From: Patrick Thomas [REDACTED]
Sent: 26 October 2023 13:01
To: Wakenshaw, Gareth
Cc: Adrian Chadha; Moises Mugerza; alanlaw; Piechocki, Amrit (E,I&S); Spencer, Will (E,I&S); Tony Burrows; Evans, Mark (E,I&S); [REDACTED]
[REDACTED]
[REDACTED]
Subject: RE: Land NE of M42 J10 2023 - Baseline Transyt Validation Report & Consildated Modelling Strategy Note NH review
Attachments: TRANSYT 2023 Baseline Model - Response to NH 2023-10-09.pdf; M42 Jn10 and A5 - Exist With Ref Case Pen Way & Dordon v5.t16; Level 1 Baseline.dwg

We have undertaken a review of the suitability of the applicant's response to previous NH comments on the TRANSYT Baseline model for the site. We thank the applicant for the latest model submission, and have included the following documents as part of our review:

Review of Modelling Relating to the Development at Land to Northeast of M42 Junction 10

Image 2.1: A5/ Core 42 – Observed Stages

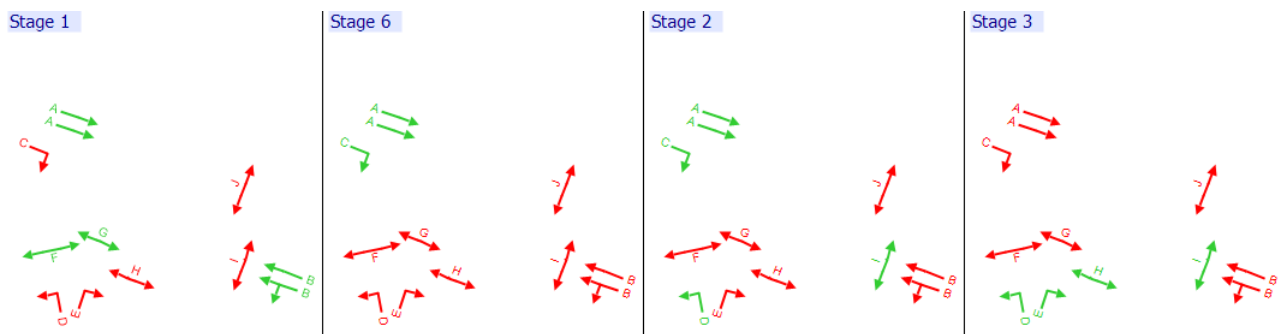
- **M42 Junction 10** – No changes have been made to the signal timings. Based on the model results, this is acceptable.
- **A5 / Birch Coppice** – The signal timings have been updated and provide a good level of validation against the observations.
- **A5 / Core 42** – We are not able to follow your revised summary of how often the stages are called at this junction (further detail below).

The staging used in the model is based on the drawing supplied previously, however this staging differs from that in the controller specification document have supplied by the applicant. Although the Stage 1s match, the modelled Stages 2 and 3 match Stages 4 and 5 in the controller specification. The AM Peak model's new Stage 6 closely replicates Stage 2 in the controller specification, but the model has not called the pedestrian phases F, G and I.

The controller specification has six stages and our analysis of the AM Peak hour signal data supplied suggests that the different stages are called this often:

- Stage 1 – 47 times
- Stage 2 – 33
- Stage 3 – 8
- Stage 4 – 9
- Stage 5 – 6
- Stage 6 – 1

Please note the above stage numbers are those in the controller specification and not those in the TRANSYT model. As only the movement green times have been supplied rather than stage frequency data, we have had to make assumptions over which stages are running when. We have not reviewed the PM Peak data to see how it matches the values used in the model.

Although it is desirable that this demand dependency is replicated in the TRANSYT model, it is more important that the TRANSYT model replicates the amount of green time observed over the modelled hour as well as possible. Although the model results are fairly consistent with the observed data, it is important to understand whether the modelled junction is receiving a similar amount of green time to that observed. As stated previously, incorrect signal timings may mask issues with the other input data such as the saturation flows.

Therefore, we ask the applicant to supply further information detailing how signal timings have been determined and the frequency of the demand dependent stages at the A5 / Core 42 junction. This would allow us to understand how the peak hour green times have been determined from the observed data.

- 2.15 In the AM peak the observed signal timings show that Phase A runs with long green periods (during Stages 1, 6 and 2) and only receives a red signal during Stage 3, i.e. when Phase E is called (right turn out of Meridian Drive). Phase B (A5 westbound) receives a green signal for 54 secs during a typical cycle and is called 47 times in the hour. Phase C is called 40 times (85% of cycles) in the hour and typically runs for 8 secs each time. Phase D is called 20 times (45% of cycles) in the hour and typically runs for 10 secs. Finally Phase E is only called 5 times (10% of cycles) in the hour and for 7 secs on average.

- 2.16 The “probability of running %” feature had been used for Stages 2 and 6, with Stage 2 (Phases A, C & D) being set to 40% and Stage 6 (Phases A & C) being set to 50%. As Phase C runs in both stages it will be called 90% of the cycles, similar to that observed on average. Phase D within Stage 2 will be called typically every 2nd cycle, also similar to that observed on average.

2.19 In the PM peak the observed signal timings show that Phase A also runs with long green times (during Stages 1, 6 and 2) and only receives a red signal during Stage 3, i.e. when Phase E is called (right turn out of Meridian Drive). Phase E is called more often than their AM peak hour, being called 12 times (23% of cycles) in the hour and for 8 secs on average. Phase B (A5 westbound) receives a green signal for 39 secs during a typical cycle and is called 54 times in the hour. Phase C is called 35 times (60% of cycles) in the hour and typically runs for 10 secs each time. Phase D is called 43 times (80% of cycles) in the hour and typically runs for 12 secs.

2.20 Similar to the AM Peak, the “probability of running %” feature has been used for Stages 2 and 6, with Stage 2 (Phases A, C & D) being set to 60% and Stage 6 (Phases A & C) being set to 10%. As Phase C runs in both stages it will be called 70% of the cycles, similar to that observed on average. Phase E in Stage 3 has been set up to be called every 4th cycle using the “run every N cycles” option. As Phase D runs in Stages 2 and 3, it will be activated approximately 80% of the cycles, similar to that observed on average.

FIGURES

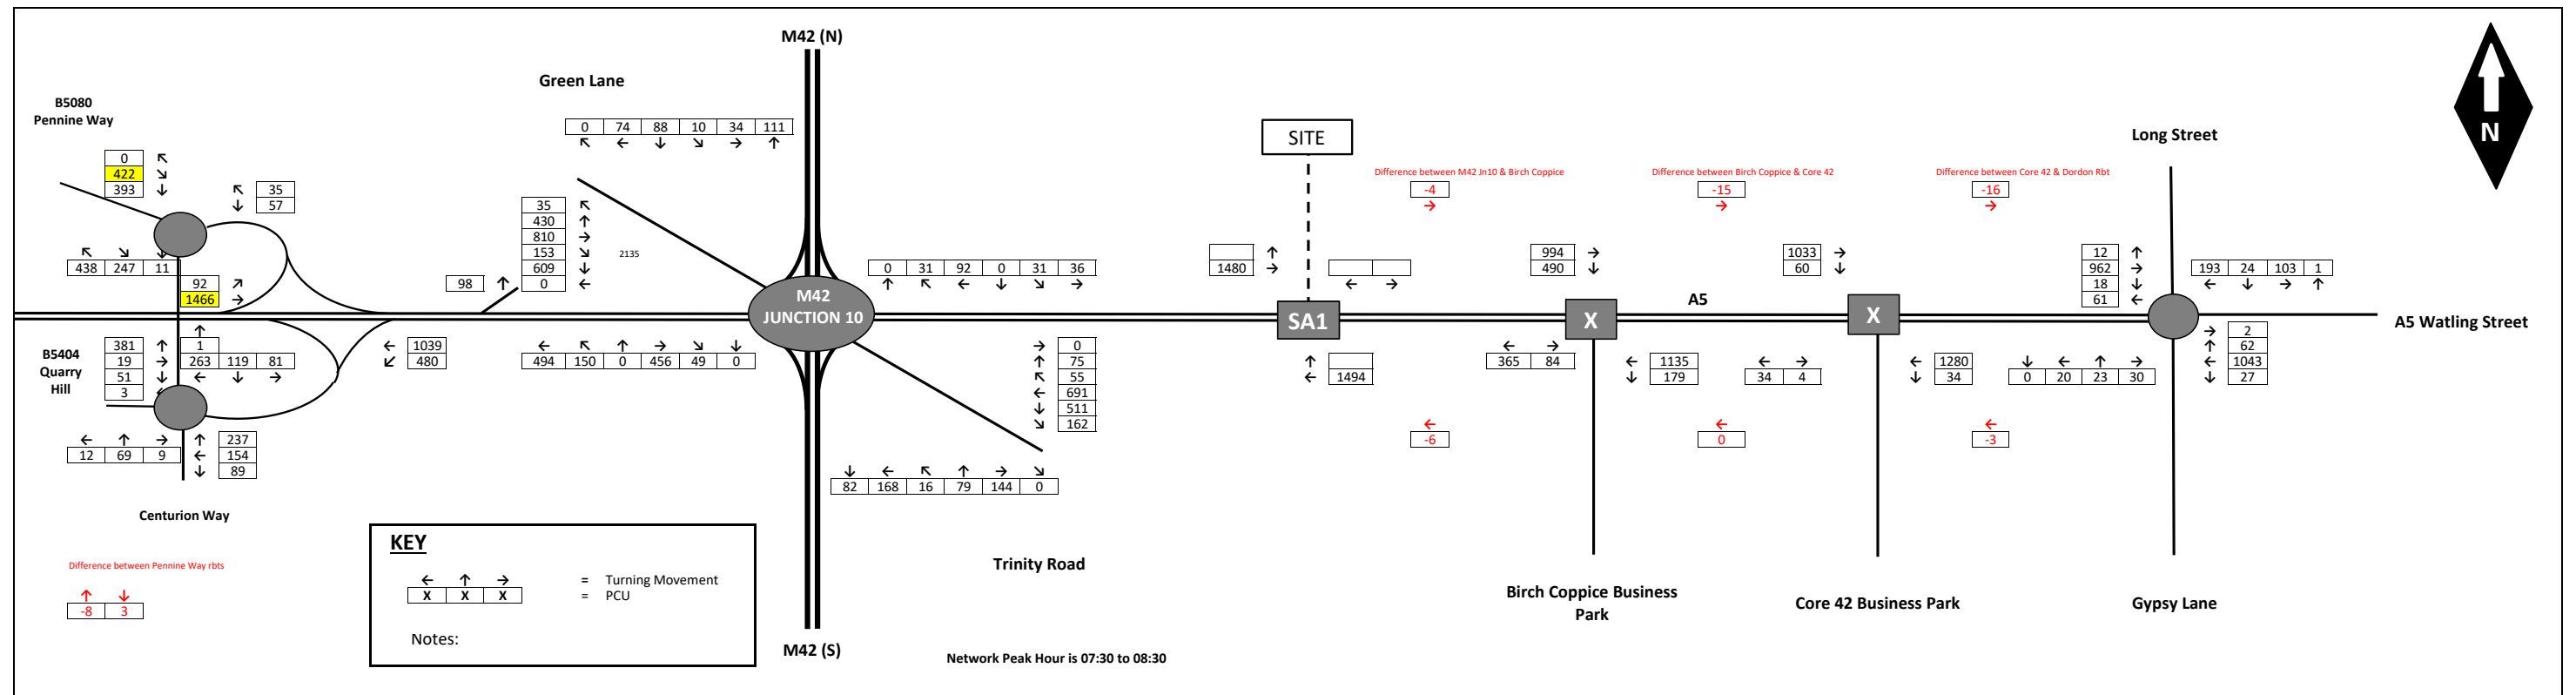
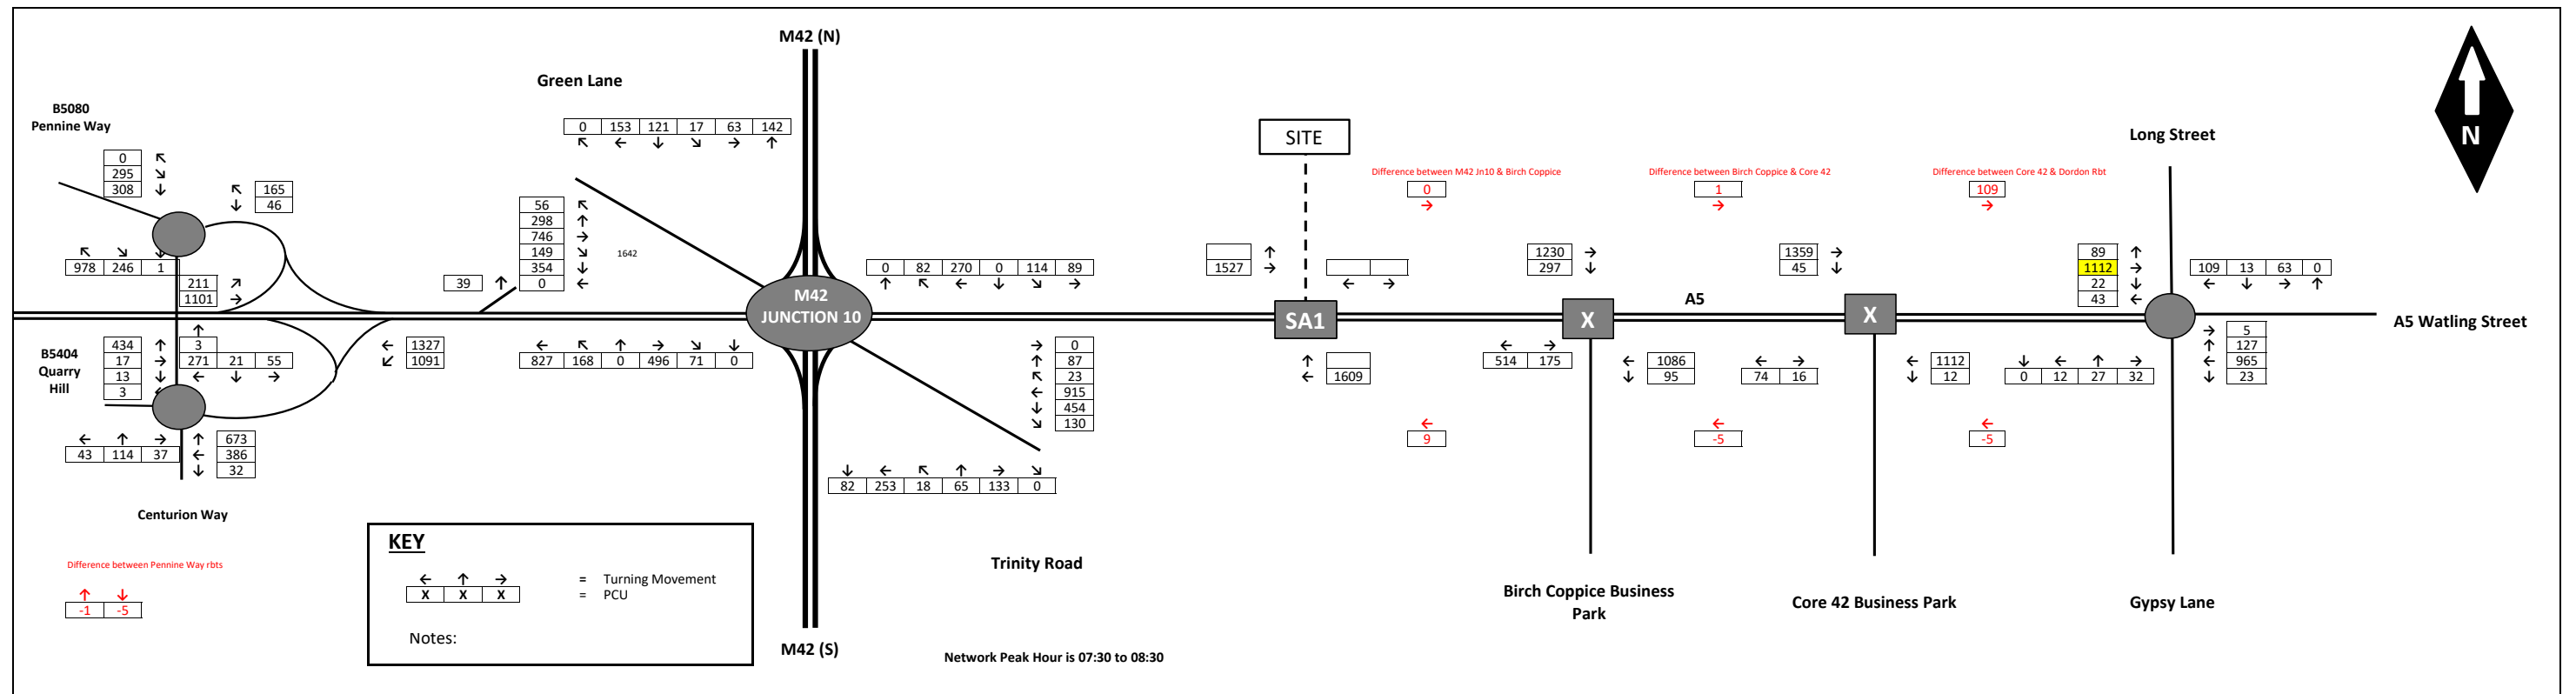
1. Traffic Flow Consistency between Nodes

Flows updated. Matter closed.

2. Traffic Flow Inputs

Flows updated. Matter closed.

- 2.1 NH state that flow discrepancies of under 10pcu could be considered insignificant if there are no obvious “sinks” in the network, particularly to the west of Junction 10. Upon review of the 2023 AM peak, the total flow departing from Junction 10 (Local Matrix 1) and heading west on the A5 (to Local Matrix 5) is 1519pcu. The total flow departing from the A5 west at Local Matrix 5 (the A5 mainline/ Pennine Way slip roads) is 1519pcu, which is the same. In the reverse direction the total flow heading east from Local Matrix 5 is 2127pcu. The total A5 west flow arriving at Local Matrix 1 is 2135pcu, thus an 8pcu difference. This slight discrepancy has been corrected so that the total flow leaving Local Matrix 5 on this movement is consistent with that arriving Local Matrix 1, refer to Figure 1v2 attached in Appendix B. The traffic flows in the model have been updated accordingly.

2.4 At Local Matrix 4 (Pennine Way Northern Roundabout) the modelled flow has been corrected for the AM peak hours as identified by NH and a revised Figure 1v2 is attached at Appendix B. The TRANSYT model has been updated accordingly.

2.5 At Local Matrix 7 (A5/ Dordon roundabout), as discussed at para 3.5 in the Validation Report, there was a difference between the A5 eastbound exit flow at the A5/ Core 42 junction and the A5 eastbound entry flow at Dordon Roundabout of 109pcu. At that time it was considered appropriate to apply a 100pcu uplift onto the ahead movement as that would result in a higher flow at the roundabout entry. However, noting NH's comments and on the A5 between the A5/ Core 42 junction and Dordon Roundabout there are a number of minor access roads, such as New Street, it is likely that the flow discrepancy results from vehicles leaving the A5 to these accesses. As a result, the A5 eastbound approach flow to Dordon Roundabout has been returned to the survey value of 1112pcu to match the observed turning counts. Traffic flow diagram Figure 3v2 attached in Appendix B refers and the model has been updated accordingly.
